March 8, 2010
W-P Project No. 12018A

Subject: Macallen Dam - Preliminary Report
Structural Analysis and Recommendations

Intent to Complete Repairs
DAM#177.01/DSP#08-023
DAM Macallen Dam

May 5, 2008
Letter of Closure
For
Letter of Deficiency

1. Concrete deterioration on upstream right abutment wall

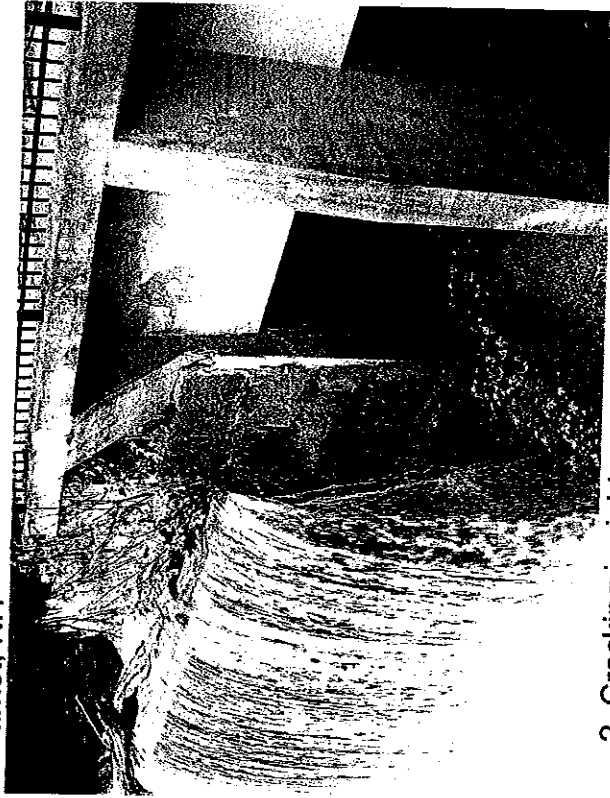
Feature	Type of deficiency M=maintenance S=structural	Observation
Upstream right abutment wall	M	Concrete deterioration - Photo 1
Right low level gate-housing wall and left spillway training wall	S	Cracking in concrete- Photo 2
Left spillway training wall -Upstream	M	Concrete deterioration -Photo 3
Gate housing pier-upstream	M	Concrete deterioration on upstream face of gate pier below permanent pool level - Photo 4
Left abutment wall - upstream	M	Concrete deterioration -Photo 5
Right abutment wall	M	Cracking in right concrete abutment wall- Photo 6
Gate structure and left spillway training wall	M	Concrete deterioration and brush growth on gate structure - Photo 7
Left abutment wall-downstream of gate	S	Leakage from left abutment wall, d/s of gate- Photo 8 & 9
Left abutment wall-upstream	S	Possible seepage path at entrance to mill building on left upstream where flood waters enter basement. - Photo 10

- c. Upstream right abutment wall
 - d. Left upstream spillway training wall
 - e. Left upstream abutment wall
 - f. Right abutment wall
 - g. Gate structure and left spillway training wall

8. Leakage from left abutment wall, d/s of gate

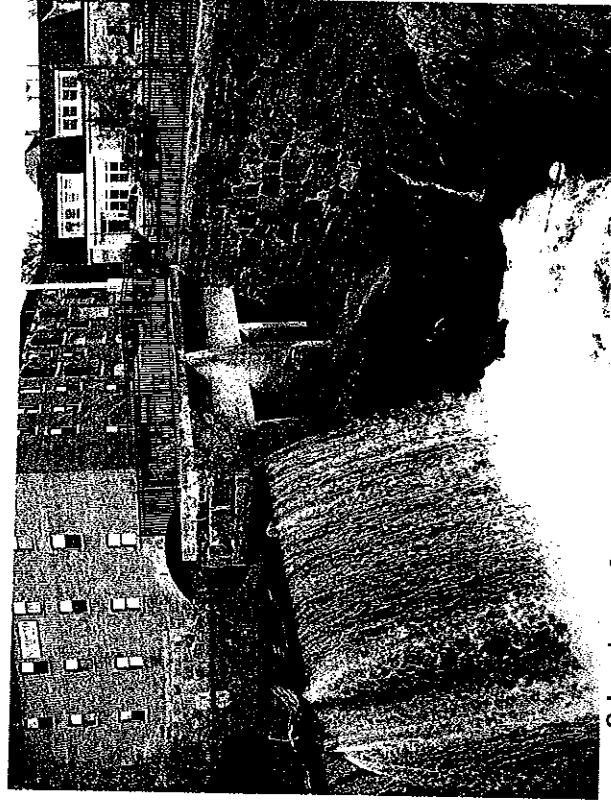
4. Remove the brush growing from the stonework in the left abutment.
5. Investigate and repair, if necessary, leakage from left abutment wall, d/s of gate, Photo 8 – 9.

11. Parking lot to the left and upstream of the dam - water enters

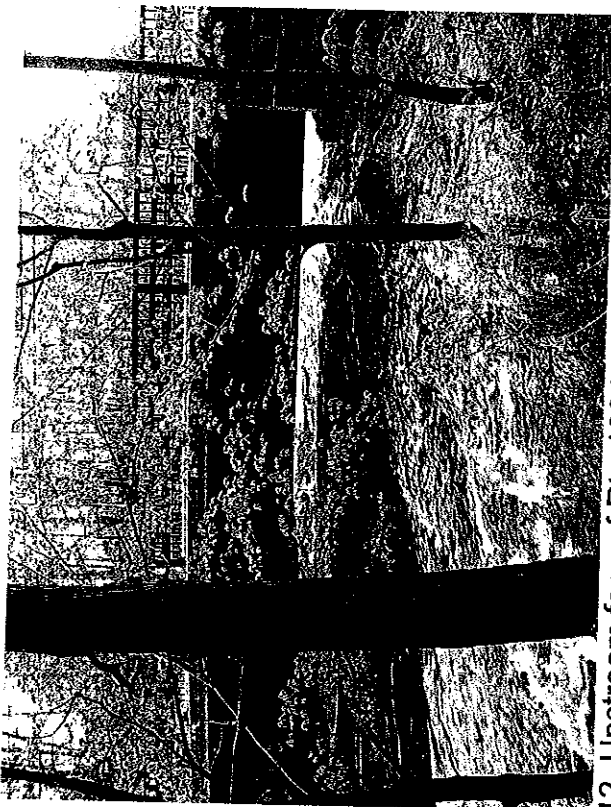
Left abutment	S	Parking lot to the left and upstream of the dam - water enters brick building basement during floods - Photo 11
Low level gates (3-7' x 7')		Operators work, some leakage from gate seals.
Operation and maintenance plan		No plan on file.
Emergency Action Plan		Needs update and testing- last test was 1997, last update 2007
